# 802.3dj D2.0

## Comment Resolution

## Common Track

Matt Brown (Alphawave Semi), 802.3dj Chief Editor  
Adee Ran (Cisco), 802.3dj Electrical Track Lead Editor

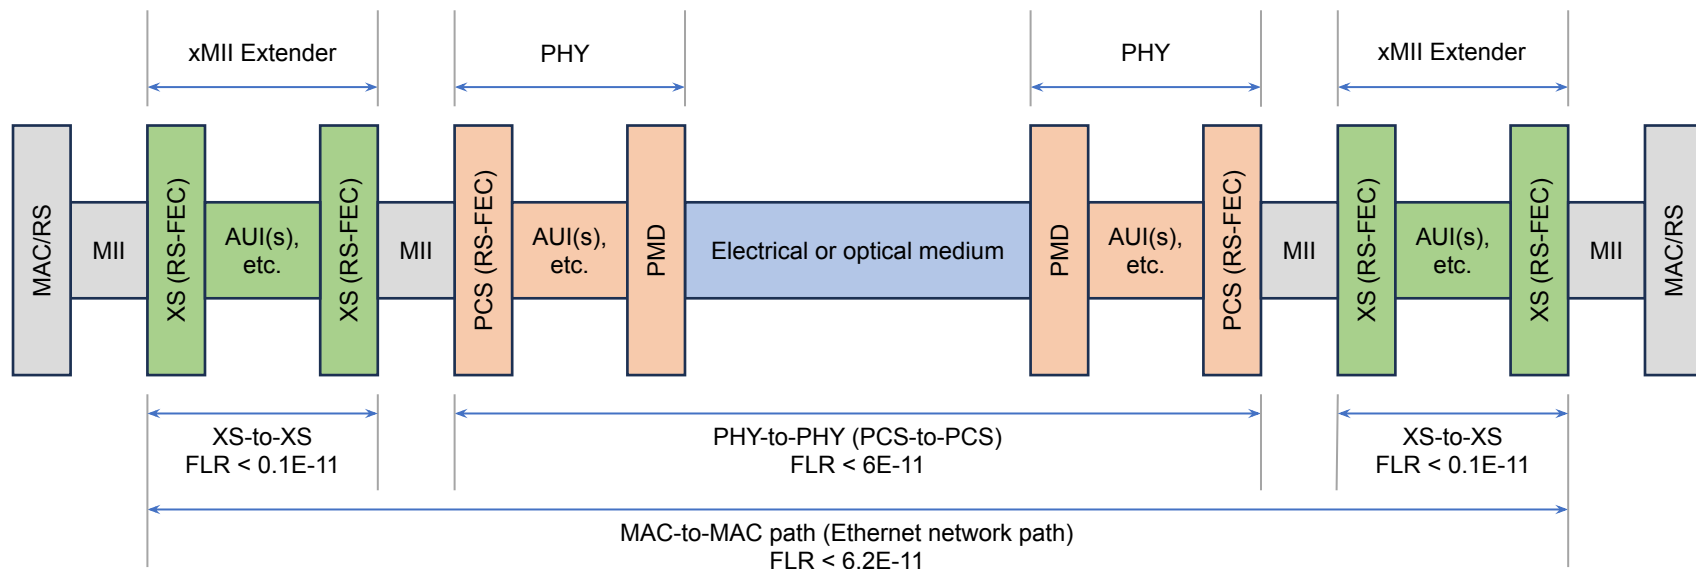
Cl 174A SC 174A P 677 L 21 # 292

Diagrams showing the various paths or domains described in 174A.3 through 174A.7 would be very helpful to the reader of the annex.

Add a diagrams illustrating the paths described in 174A.3 through 174A.7.

Add a figure to show the link in 174A.5, 174A.6 and 174A.7

#292 and #106 propose adding figures to help understand the context for each of the error ratio allocations.

Note also, that #590 (in bucket #1) proposes to rename "network path" to "mac-to-mac path".

PROPOSED ACCEPT.

PROPOSED ACCEPT IN PRINCIPLE.  
Resolve using the response to comment #292.

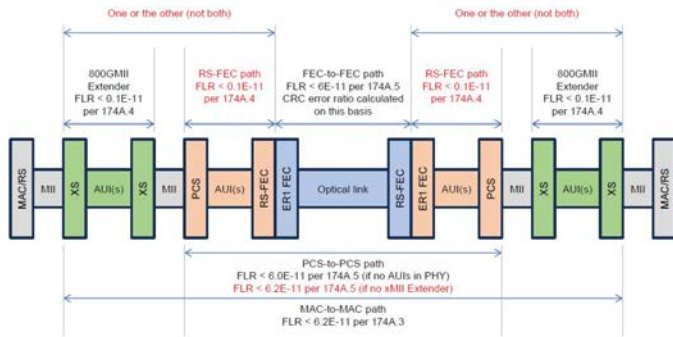
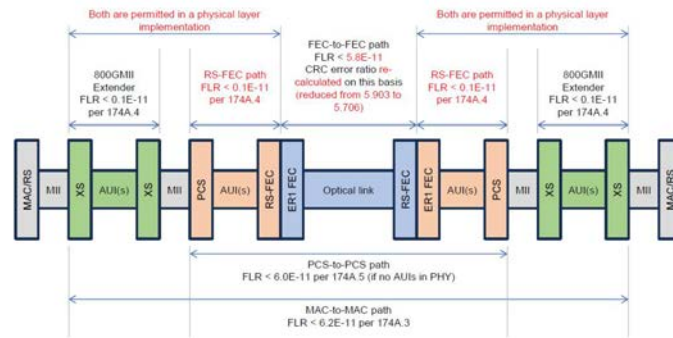
Option #2: Allow either AUIs in the PHY or Extender, but not both

Option #3: Reduce FLR option for ER1 FEC path

For 800GBASE-ER1/ER1-20...

Option #2 (above) was adopted in Draft 1.5.

- Requires different figure

D2.0 comment #xxx proposes to adopt option # (right)

- Can use same figure as previous slide, if adopted

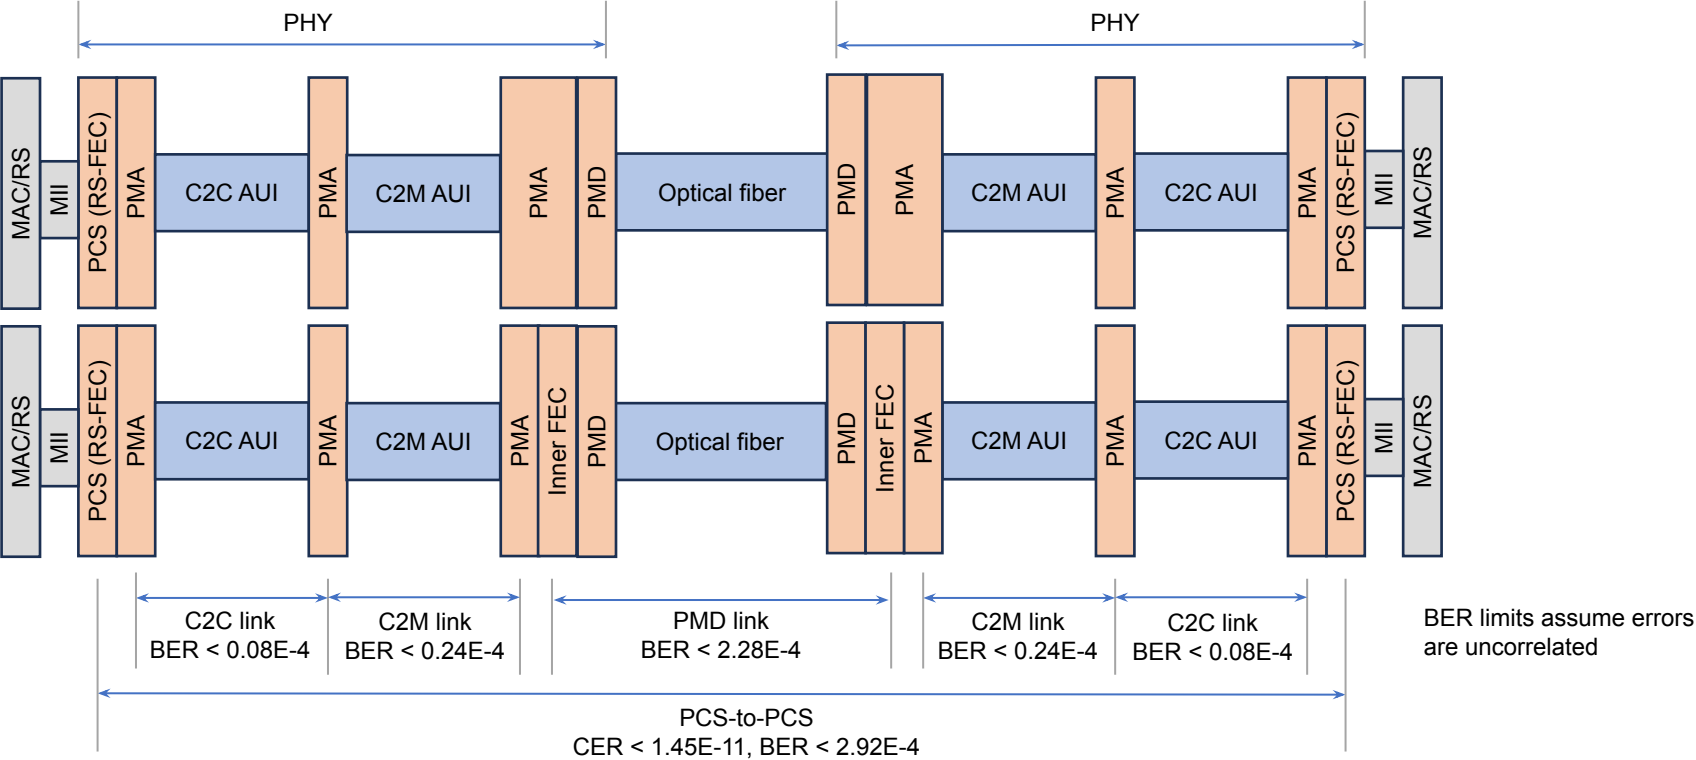
Cl 174A	SC 174A.6	P 678	L 28	# 585
Nicholl, Gary		Cisco Systems		
Comment Type	TR	Comment Status	D	(Common) FLR allocation
FLR allocation for 800GBASE-ER1/ER1-20.				
During the March plenary the consensus was to adopt option# 2 of <a href="https://www.ieee802.org/3/dj/public/25_03/brown_3dj_04a_2503.pdf">https://www.ieee802.org/3/dj/public/25_03/brown_3dj_04a_2503.pdf</a> , for the FLR allocation for 800GBASE-ER1/ER1-20.				
Also, see the final response to comment #16 in <a href="https://www.ieee802.org/3/dj/comments/D1p4/8023dj_D1p4_comments_final_clause.pdf">https://www.ieee802.org/3/dj/comments/D1p4/8023dj_D1p4_comments_final_clause.pdf</a> .				
An implication of this decision is that 800GBASE-ER1/ER1-20 PHYs are different from other 802.3dj PHYs, in that you are only allowed to have AUIs in the PHY or Extender, but not both (see slide 18 of brown_3dj_04a_2503). For other 802.3dj PHYs you are allowed to have AUIs in both the PHY and the Extender.

This means it is possible to have a host design that contains two AUIs (one in an Extender and one in the PHY) that would not support an 800GBASE-ER1/ER1-20 PHY, but would support all other 802.3dj PHYs.				
I don't think that an 800GBASE-ER1/ER1-20 PHY should be treated as a special case.				
I propose changing the FLR allocation for the 800GBASE-ER1/ER1-20 PHY to be consistent with all other 802.3dj PHYs, such that there are no restriction on which hosts an 800GBASE-ER1/ER1-20 PHY can be deployed in.				
This is essentially option #3 in brown_3dj_04a_2503, where the FLR of a 800GBASE-ER1/ER1-20 PHY, with or without an AUI, is defined as 6 x 10 <sup>-11</sup> (consistent with all other 802.3dj PHYs). This in turn means reducing the FLR for the ER1-to-ER1 FEC link from 6 x 10 <sup>-11</sup> to 5.8 x 10 <sup>-11</sup> .				
<i>Suggested Remedy</i>				
Change the FLR allocation for 800GBASE-ER1/ER1-20 to implement option #3 in <a href="https://www.ieee802.org/3/dj/public/25_03/brown_3dj_04a_2503.pdf">https://www.ieee802.org/3/dj/public/25_03/brown_3dj_04a_2503.pdf</a> .

Make the necessary changes in clauses 187 and 174A.				
A supporting presentation will be provided.				
Proposed Response		Response Status	W	
PROPOSED REJECT.				
The comment proposes to change a decision made by the CRG as detailed in the comment. However, the comment makes a good case and a proposal is forthcoming.				
Pending task force review of the supporting contribution.

Comment #585 proposes to change the FLR budgeting for 800GBASE-LR1. The appropriate diagram can be used once that decision is made. Shown here for reference.

Per-lane state diagram

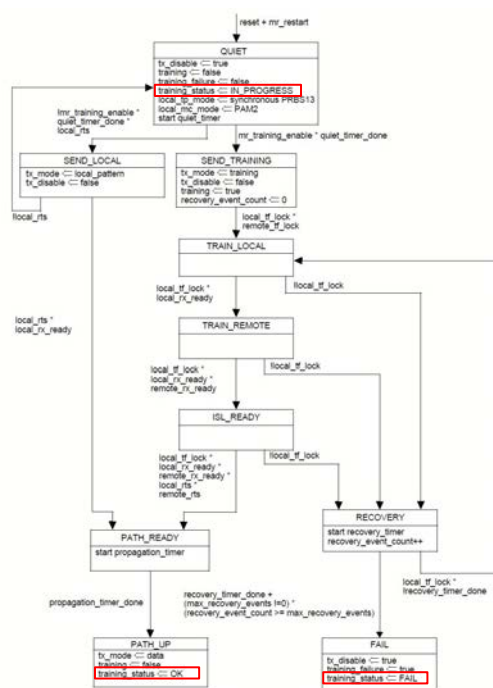
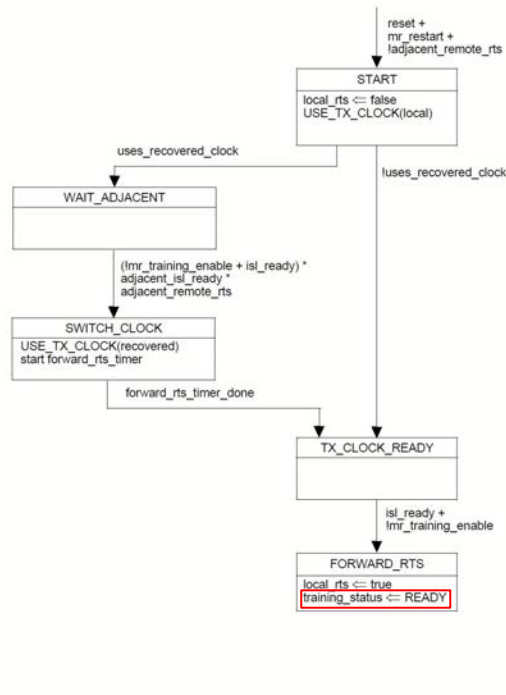
Training status can not be both a AUI component variable and a per-lane training variable.  
Local\_rts is an equivalent status to it and is mapped to a MDIO register bit.

Move the definition of training\_status to 178B.14.3.1  
Remove the enumeration of "READY" from its definition.  
Delete training\_status <= READY from Figure 178B-7

The variable training\_status is used by the 'Training control state diagram' in subclause 178B.14.3.5 'State diagram figures' but is not defined in the associated subclause 178B.14.3.1 'Variables'.

In addition, it appears that the training\_status is a per-interface variable based on the definition found in 178B.14.2.1 'Variables', yet it appears to be driven by both the per-interface 'RTS update state diagram' (Figure 178B-7) and the per-lane 'Training control state diagram' (Figure 178B-8). I'm not sure how this would operate.

As an example, if the Training control state diagram on one lane in an interface enters the FAIL state, it would set training\_status for the interface to FAIL. If, however, the Training control state diagram on another lane in the same interface enters the PATH\_UP state immediately afterwards, training\_status for the interface would then be set to OK. This doesn't seem to be correct.

Provide a definition for the training\_status variable used in Figure 178B-8 'Training control state diagram' in its associated subclause 178B.14.3.1 'Variables'. In addition, clarify the operation of training\_status regarding it being driven by both the per-interface 'RTS update state diagram' (Figure 178B-7) and the per-lane 'Training control state diagram'.

Problem:

training\_status is defined as a per-interface variable (in 178B.14.2.1), but it appears in both per-lane and per-interface state diagrams. Formally there needs to be more than one variable.

Note that the value READY is assigned only be the per-interface state diagram; READY is equivalent to (all lanes are IN\_PROGRESS) and (local\_rts is true).

PROPOSED ACCEPT IN PRINCIPLE.  
training\_status is used by the PMDs and AUIs (see 178.4, 179.4, 180.3, 181.3, 182.3, 183.3, 176C.6 and 176D.4) so it shall be assigned a value by ILT.  
It is a per-interface variable that is assigned to all lanes of the interface.  
Define a new variable in 178B.14.3.1: lane\_training\_status. Defined as: Enumerated variable that indicates the status of the per-lane ILT function. This variable may be assigned one of the following values: IN\_PROGRESS, OK, FAIL.  
Use this new variable in the per-lane state diagrams instead of training\_status.  
Change the definition of the variable training\_status to: Enumerated variable that indicates the status of the per-interface ILT function. This variable may be assigned one of the following values: IN\_PROGRESS, READY, OK, FAIL. The value READY is assigned by the RTS update state diagram (Figure 178B-8) and other values are assigned according to the lane\_training\_status variable (see 178B.14.3.1):

IN\_PROGRESS - lane\_training\_status variable = IN\_PROGRESS for any lane assigned to the interface  
OK - lane\_training\_status variable = OK for all lanes assigned to the interface  
FAIL - lane\_training\_status variable = FAIL for any lane assigned to the interface  
Implement with editorial license.

Define a new variable in 178B.14.3.1 (Per-lane variables): lane\_training\_status

Enumerated variable that indicates the status of the training control state diagram. This variable may be assigned one of the following values: IN\_PROGRESS, OK, FAIL.

Use this new variable in the per-lane state diagrams instead of training\_status.

**Option A:** keep it as a state diagram variable and change its definition as follows:

**Option B:** delete its assignment from the per-interface state diagram (Figure 178B-8), making it a non-state-diagram variable, and use the following definition:

Enumerated variable that indicates the status of the ILT function. This variable may be assigned one of the following values: IN\_PROGRESS, READY, OK, FAIL. Assignment to this variable occurs both by the RTS update state diagram (Figure 178B-8) and by changes to the lane\_training\_status variables of the lanes in the interface, as follows:

- = IN\_PROGRESS: assigned when lane\_training\_status = IN\_PROGRESS on all lanes.
- = READY: assigned by the RTS update state diagram.
- = OK: assigned when lane\_training\_status variable = OK on all lanes
- = FAIL: assigned with lane\_training\_status variable = FAIL on any lane

Enumerated variable that indicates the status of the ILT function. This variable may be assigned one of the following values: IN\_PROGRESS, READY, OK, FAIL. This variable is assigned as follows:

- = IN\_PROGRESS: if lane\_training\_status = IN\_PROGRESS on all lanes and local\_rts = false
- = READY: if lane\_training\_status = IN\_PROGRESS on all lanes and local\_rts = true
- = OK: if lane\_training\_status = OK on all lanes
- = FAIL: if lane\_training\_status = FAIL on any lane
